Docket No. 52-021  
MHI Ref: UAP-HF-08245

**Subject: MHI's 3<sup>rd</sup> Response to NRC's Requests for Additional Information on US-APWR Topical Report: Non-LOCA Methodology, MUAP-07010-P**

MHI's 3<sup>rd</sup> Response to NRC's Requests for Additional Information on  
US-APWR Topical Report: Non-LOCA Methodology, MUAP-07010-P

Figure 2.2-2.2 Flowchart of the Discontinuity Factor Process

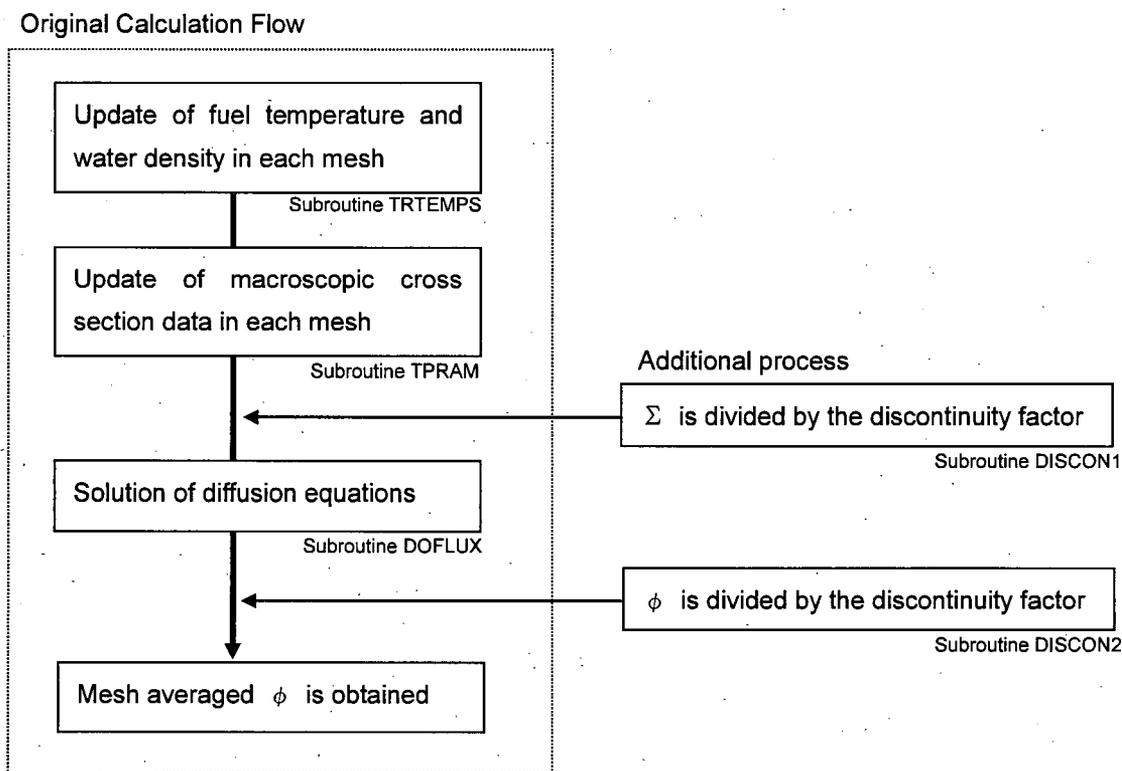
Elaborate further on the development history of TWINKLE-M. Are there any differences between the TWINKLE version used to develop TWINKLE-M and the NRC approved version described in WCAP-7979-P-A? Include, if possible, a figure describing the development of TWINKLE-M analogous to the figure describing the development of MARVEL-M found on page 2-3 of MUAP-07010-P.

A discontinuity factor was added as a new input process in the program. The purpose of the discontinuity factor is to improve the representation of the local power distribution in the three-dimensional calculations. The addition of the discontinuity factor does not change the diffusion equations in TWINKLE. Instead, the discontinuity factor implementation is shown in Figure 2.2-2.2 and described as follows:

- The macroscopic cross section data is divided by the discontinuity factor before solving the diffusion equations (additional process).
- The neutron flux is solved using the unchanged TWINKLE diffusion equation subroutine.
- The neutron flux is divided by the discontinuity factor to determine the mesh averaged neutron flux (additional process).
